Request For Information - 037.1

The Cora Apartments (19 W Harrison)

Subject:	**Tub & Shower Installation Details Clarification**	**Status:**	**Open**
Drawing #:	A0203	**Spec Sect #:**	
Addendum:		**Submittal #:**

SHEET NUMBER
A0203

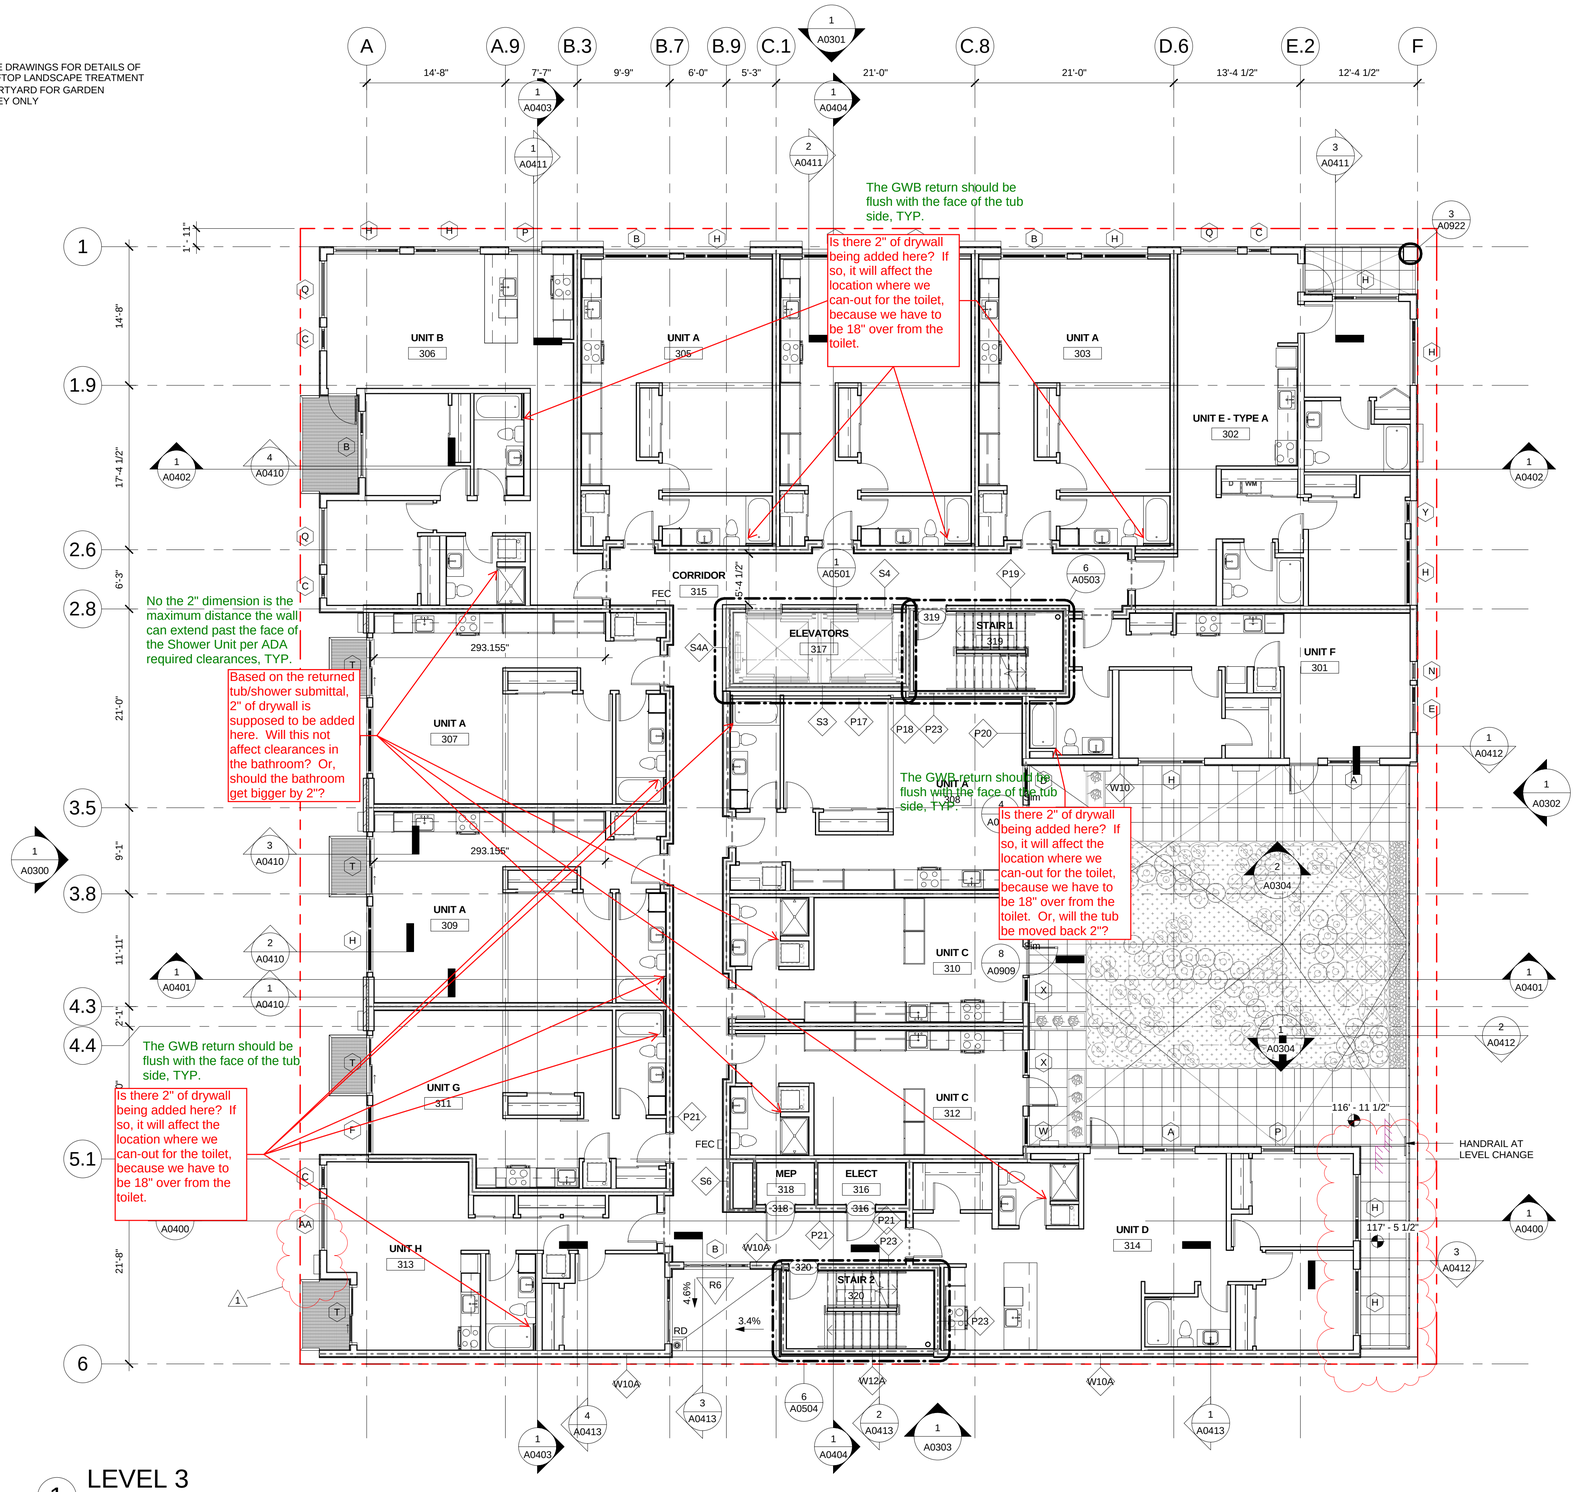
Please respond to some additional questions from our plumbing subcontractor, on the attached sheet A0203. Should 2" furring be added in the baths with tubs (extended beyond the face of the tub), similar to the wall at the showers, as shown in the submittal 22 0000-05 Tub & Shower Data (see the attached sheet)?

Date	Response
9-2-2016	See green text responses on next two pages.
	JXW
